Mirage DSK-8
Service Bulletins

For Mirage serial numbers 10001 - 14731

These service bulletins refer to the original Mirage DSK-8 Sampler.

FIGURE 7 - SHUGART SA300 DISK DRIVE

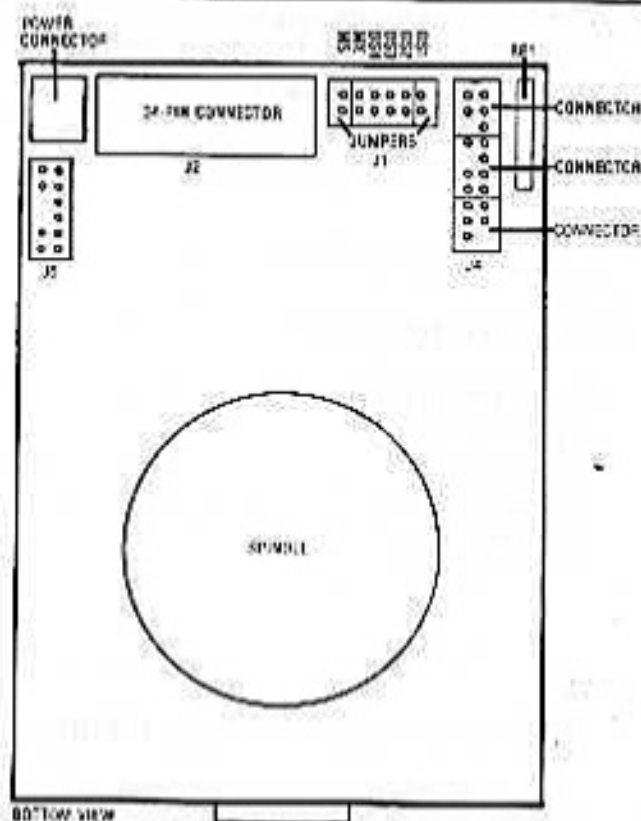
1. Remove the drive from the Mirage as per the instructions in SECTION D-1 . . . 4 of the Mirage Service Manual.
2. Orient the drive as shown in FIGURE 7.
3. Check the internal connectors of the disk drive at positions J4 and J5 (the J5 connector is one wiring harness while the J4 connector contains 3 separate wiring harnesses).
4. If you find that any of the connectors are not fully seated or completely off the terminals, reinstall the connectors, making sure that they are fully seated.
5. Reinstall the disk drive according to the instructions in SECTION D-5 . . . 8 of the Mirage Service Manual and test the unit.
6. If this procedure corrects the problem, then glue the connectors at J4 and J5 to the circuit board with hot glue.
7. If this procedure does not correct the problem, then the disk drive is bad. Remove the drive and return it to Ensoniq.

FIGURE 8

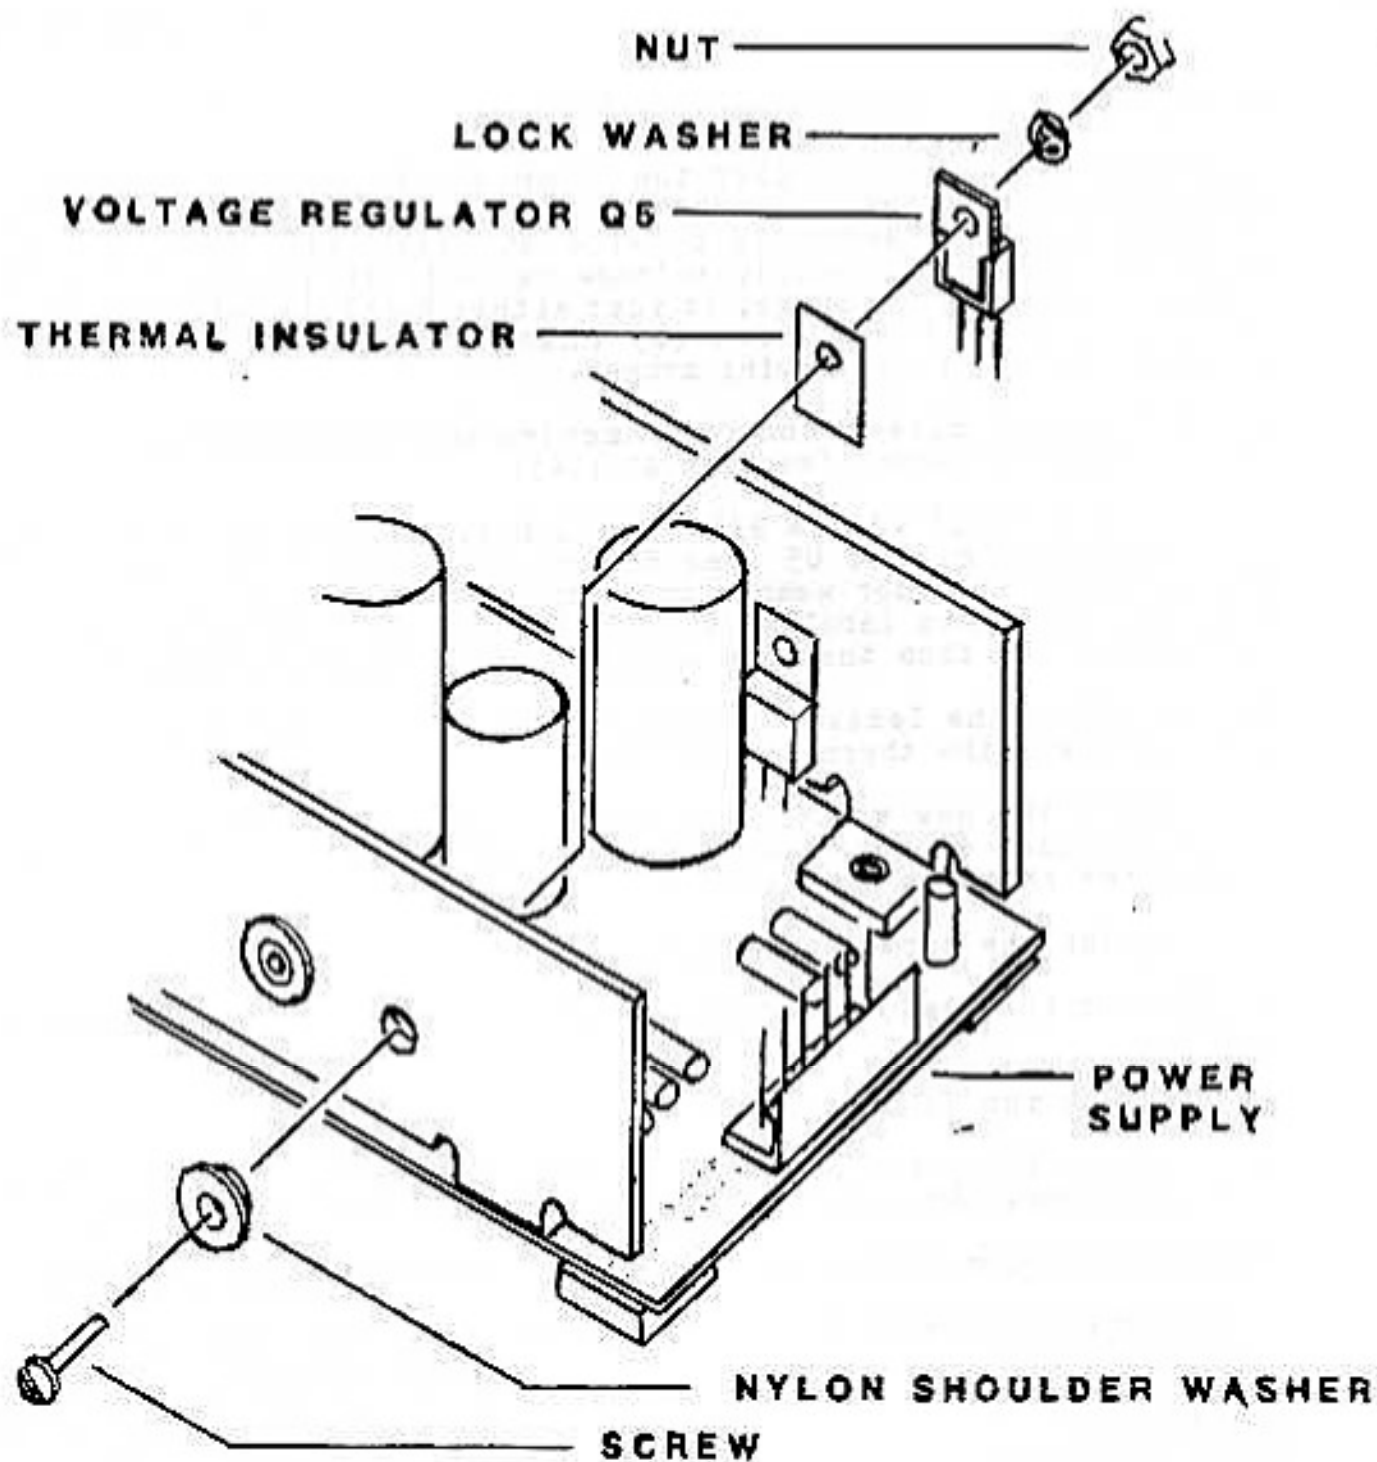
When you have narrowed down the diagnosis to warrant replacing the main board, always check the power supply for a +12V DC-8V DC voltage value. (Refer to Service Bulletin #1, section 5 to determine the power supply voltage value.) If the power supply does not have this voltage, it must either be replaced with a new power supply or modified (by changing one of the voltage regulators) in the following manner.

1. Follow the directions for removing the power supply in the Mirage Service Manual (section A1...4).
2. Using a drill with a 9/64" drill bit, drill out the rivet on the regulator marked Q5 (see Figure 8). This is the only one with a nylon shoulder washer on those power supplies which have 5 voltage regulators labelled Q1, Q2, Q3, Q4, Q5. The rivet should be drilled out from the side with the nylon shoulder washer.

3. Desolder the leads of voltage regulator Q5 and remove the regulator and the thermal insulator.
4. Insert the new voltage regulator (7908) in Q5 along with the nylon shoulder washer, the thermal insulator, the screw, nut and lockwasher as shown in figure 8.

5. Tighten the screw on regulator Q5.
6. Solder the leads of regulator Q5 on the bottom of the power supply.
7. Inspect for solder joints.
8. Replace the power supply as per the directions in the Mirage Service Manual (A5...6) and allow to burn-in for a few hours.

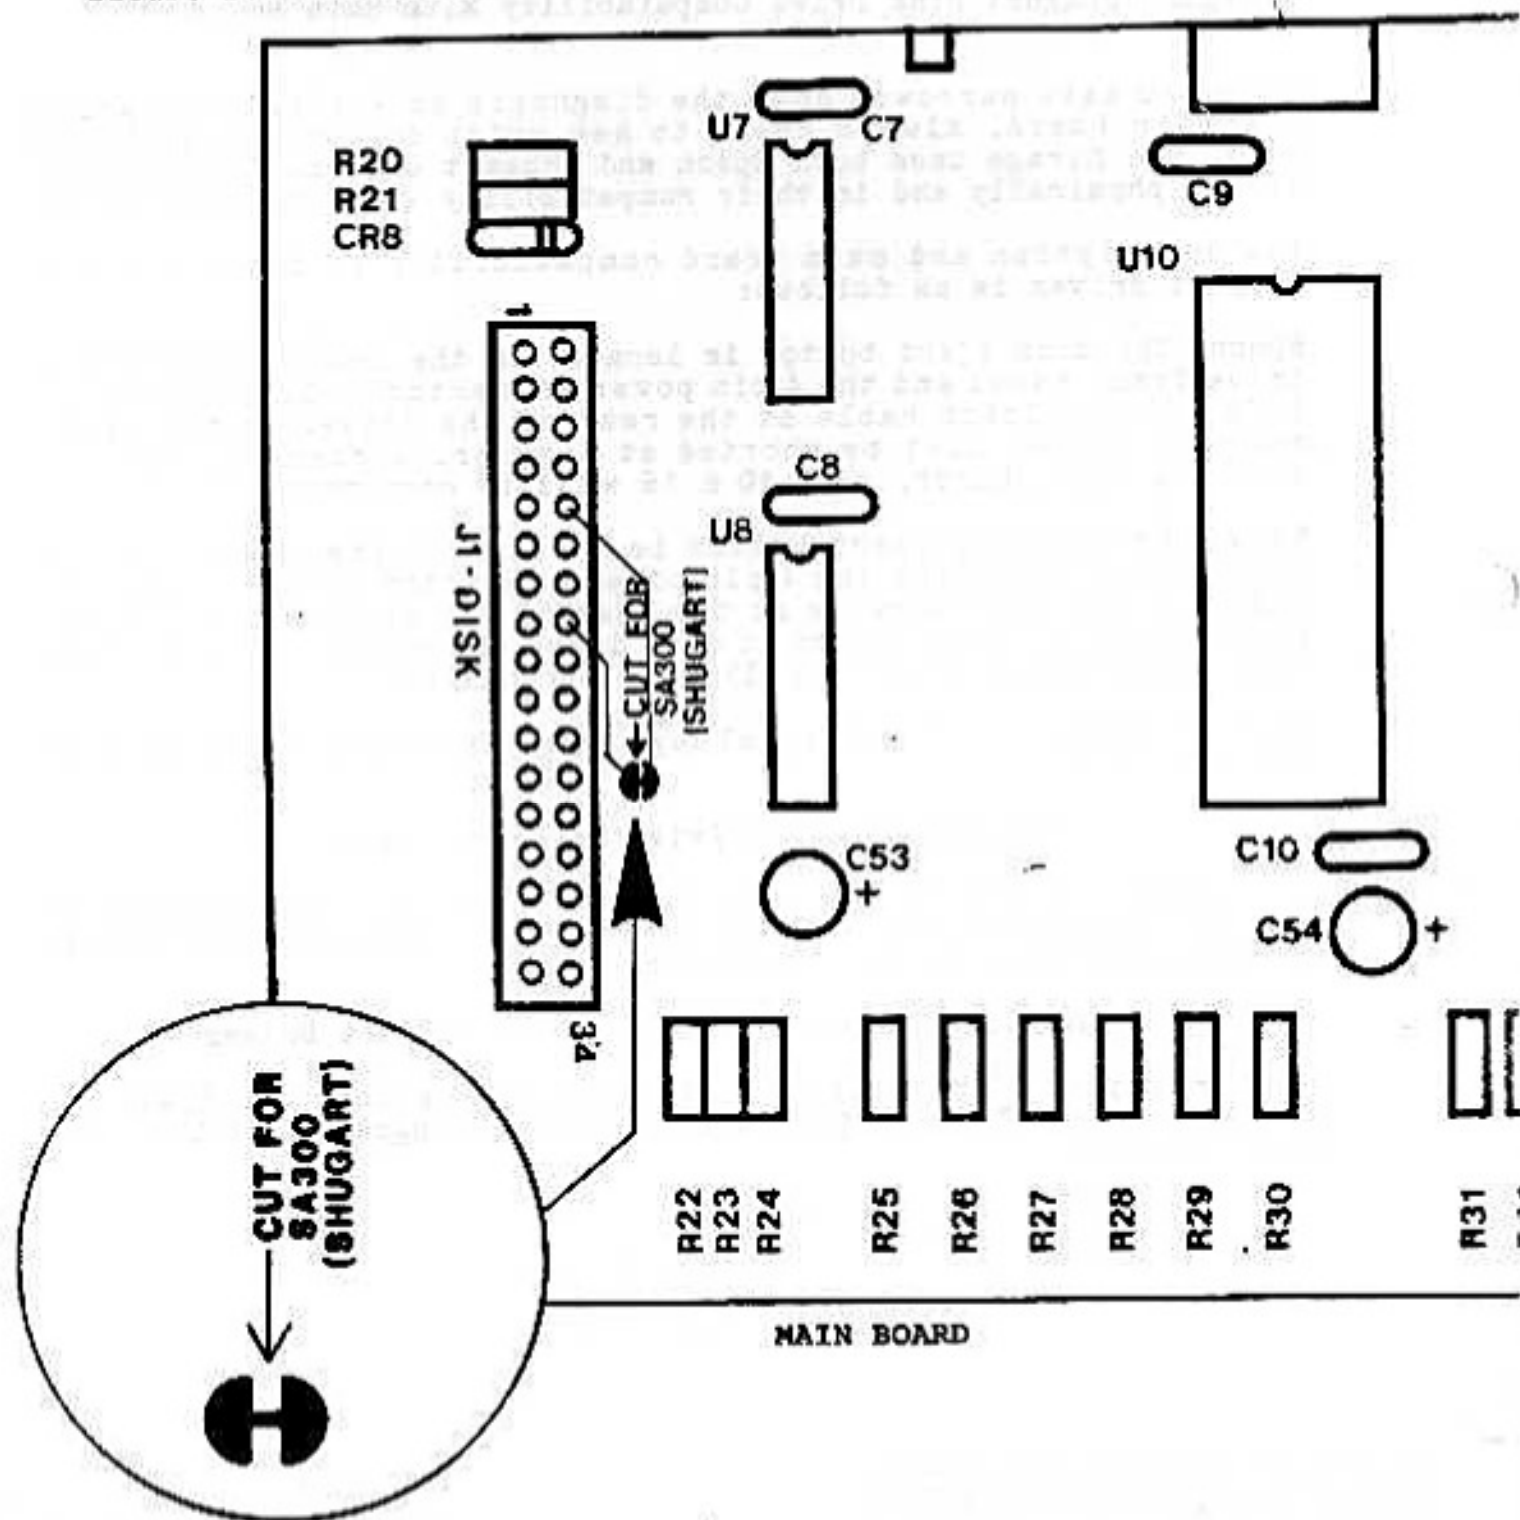
The jumper should be cut with a Xacto-Knife (or equivalent) as per instructions in the blow-up of the Disk Drive selector jumper on the other side of this bulletin.

Make the cut on this thin trace that runs between the two pads for the disk drive selector jumper. If the trace is cut at both ends where they connect to each pad it can be peeled off the circuit board using a xacto knife (or equivalent type of knife). This will yield a clean jumper cut and will leave the solder pads intact for future reconnection.

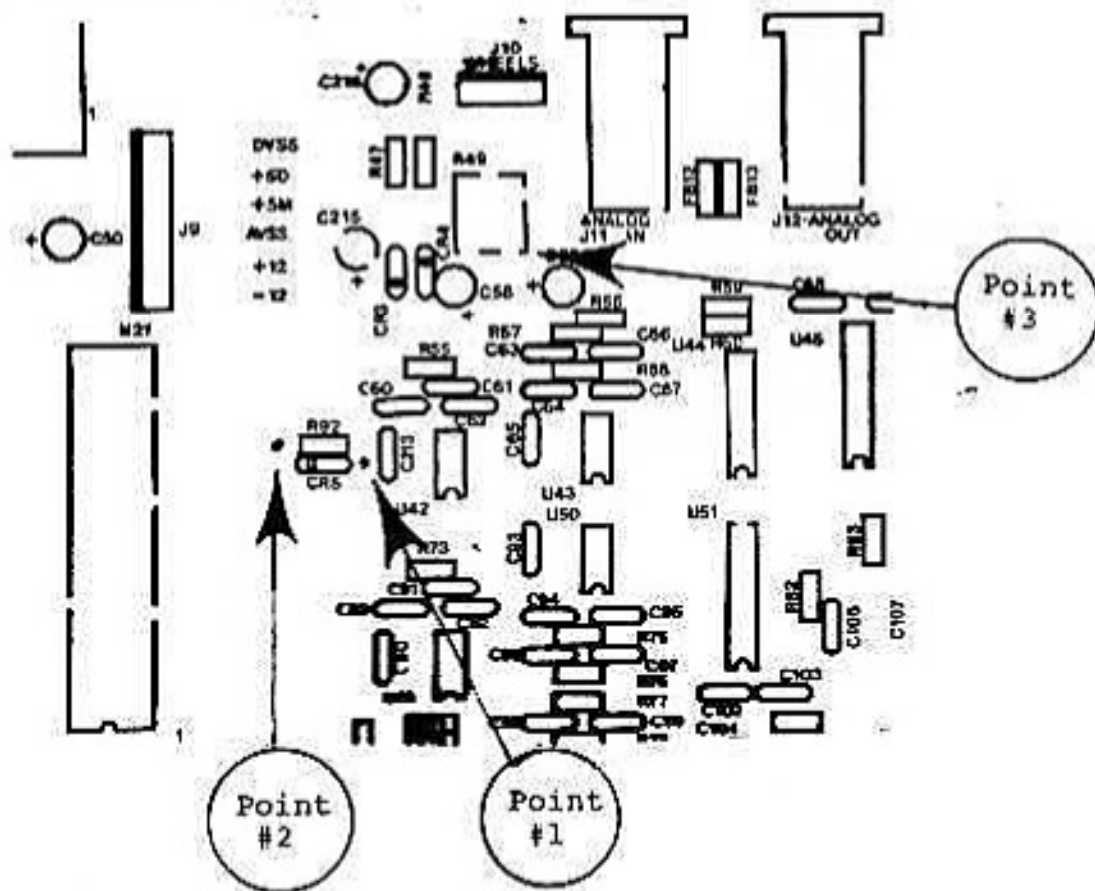
When replacing the Mirage Main Board or the Mirage Power Supply, careful attention must be given to re-adjusting the trimpot located at R49 (Point #3) on the main board. This trimpot sets the volume reference voltage going into the "Q" chip (U21) and if it is not set properly, audio distortion is likely to occur. R49 is located in the upper right hand side of the board, to the left of the Analog-In jack (J11) and directly below the Pitch/Mod Wheel connector, (J10).

The voltage reference point can be accessed by placing the positive probe of your meter on the right lead of CR5, a diode located on the lower right of R92, (point #1). Place the negative probe to Ground, the left lead of R92 (point #2). Adjust the trimpot (point #3) until the meter reads 50 millivolts, or .050 VDC.

3A

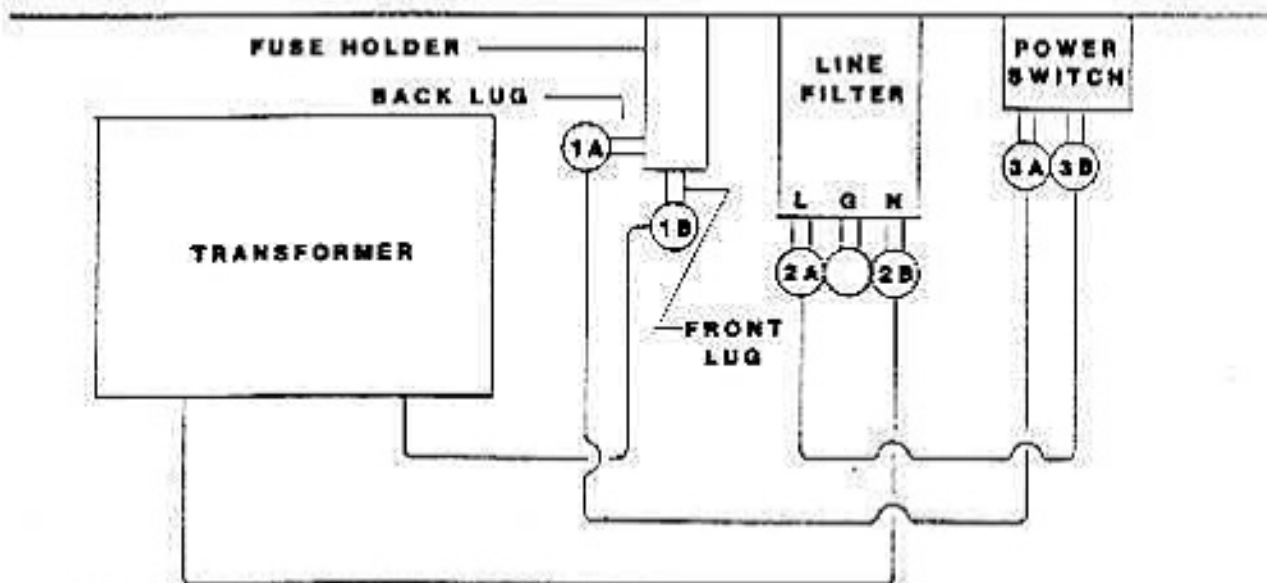
THIS BULLETIN CORRECTS FIGURES 3A AND 3B OF THE SERVICE MANUAL

AC LINE VOLTAGE CHECK POINTS
WIRING FOR EARLY MODEL CASE (WHERE TRANSFORMER IS ON THE LEFT).

3B

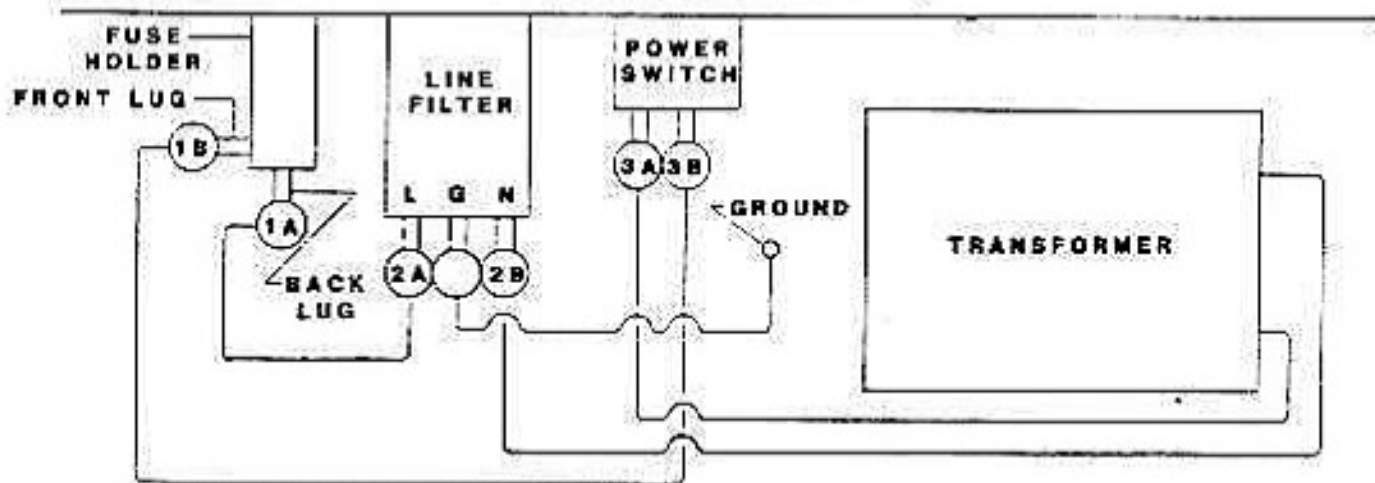
AC LINE VOLTAGE CHECK POINTS
WIRING FOR LATE MODEL CASE (WHERE TRANSFORMER IS ON THE RIGHT).

FIGURE 1

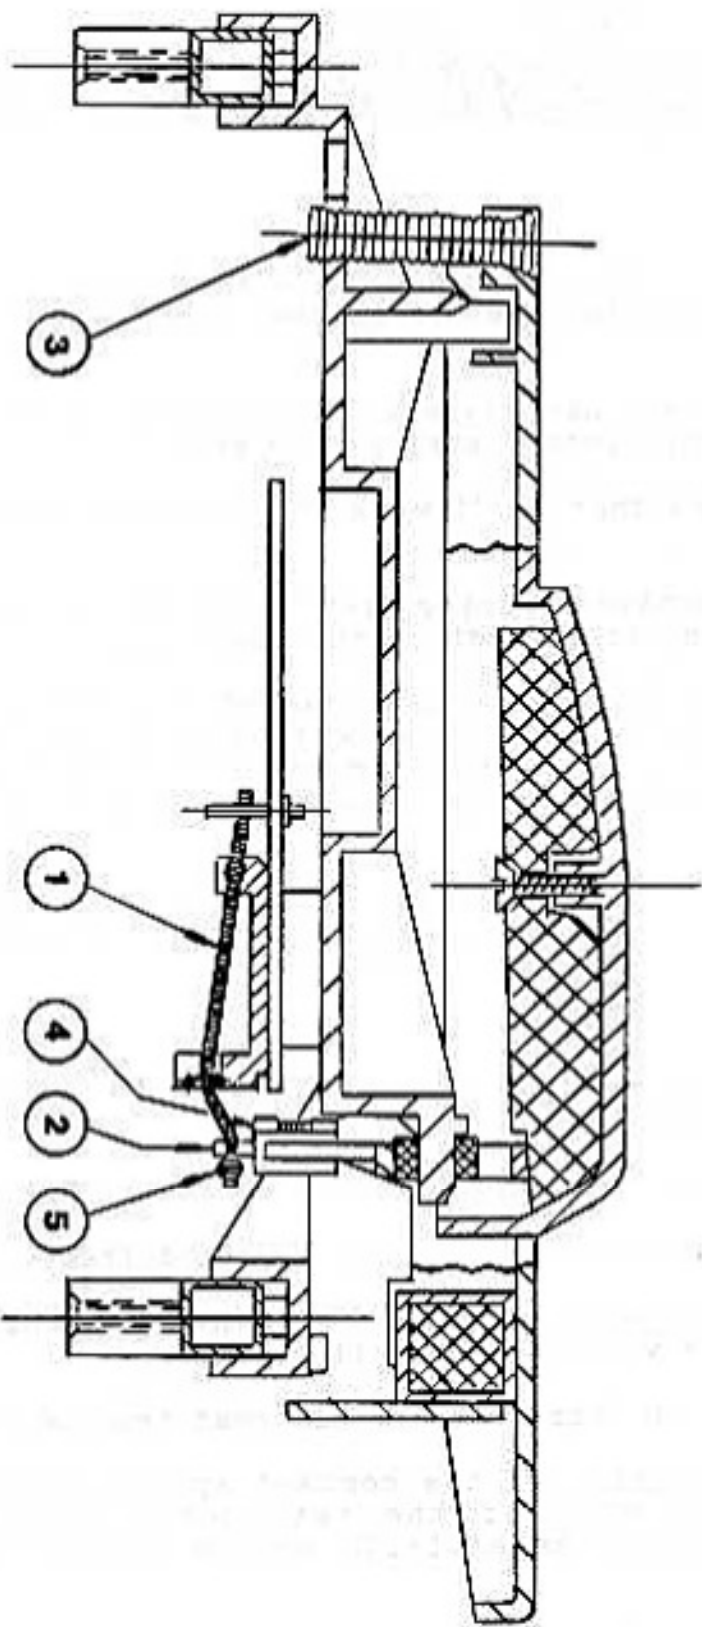
Cause: The contact spring may come loose from the front retainer, causing it to rest on the lower contact bar.

1. Detach contact spring from nylon retainer. Fig 1, item 1 & 2.
2. Remove rear tension spring from keyboard frame. Fig 1, item 3.
3. Slide key forward, up and out. (When replacing black keys first remove the white keys on either side.)
4. Seat new key on frame and install rear tension spring.
5. Adjust the height of the contact spring retainer so it is level with the rest of the retainers. This will ensure consistent velocity sensitivity across the keyboard. Fig 1, item 4.
6. Replace the contact spring into the retainer.

Solution: While the spring is detached from the nylon retainer, tin the ball end of the spring with a small amount of solder. Carefully replace this end into the retainer. The solder will prevent the contact spring from working its way through the retainer. Fig 1, item 5.
